INNER WEST COUNCIL

**SUBMISSION FROM INNER WEST COUNCIL
TO THE DEPARTMENT OF PLANNING, INDUSTRY & ENVIRONMENT
OPPOSING THE PROPOSED WESTCONNEX STAGE 3 (M4-M5 LINK – ROZELLE
INTERCHANGE) - SSI-7485-MOD-2**

SEPTEMBER 2019

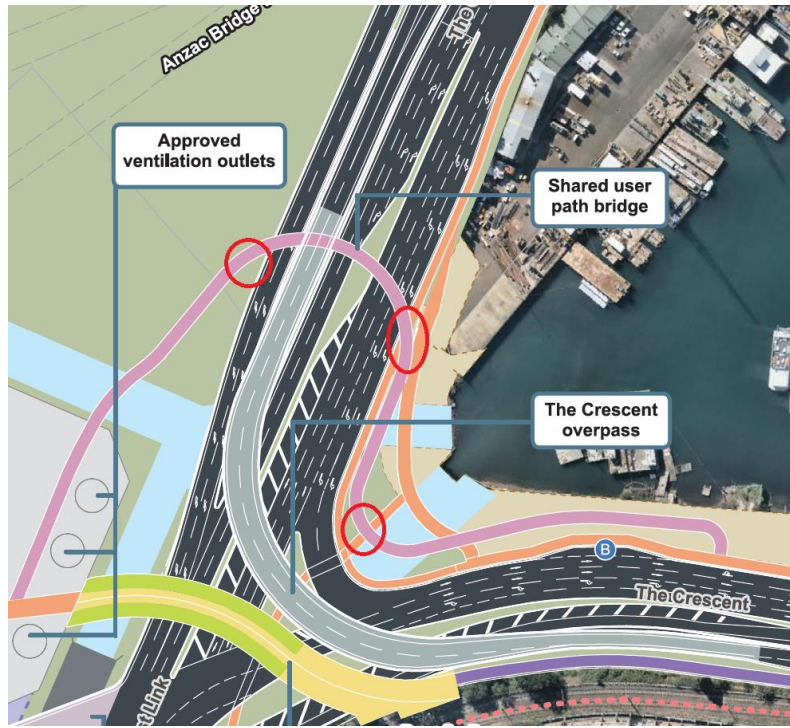
7. On the proposed shared user path, stairs be provided to minimise unnecessarily long and circuitous walking distances and provide an opportunity for people to exit the overbridge quickly and gain the attention of passing motorists if they feel unsafe.

Suggested stair locations are shown below and should account for future pedestrian movements resulting from revitalisation of the Bays Precinct. The connections should be legible and direct to provide faster walking access for people who can use them.
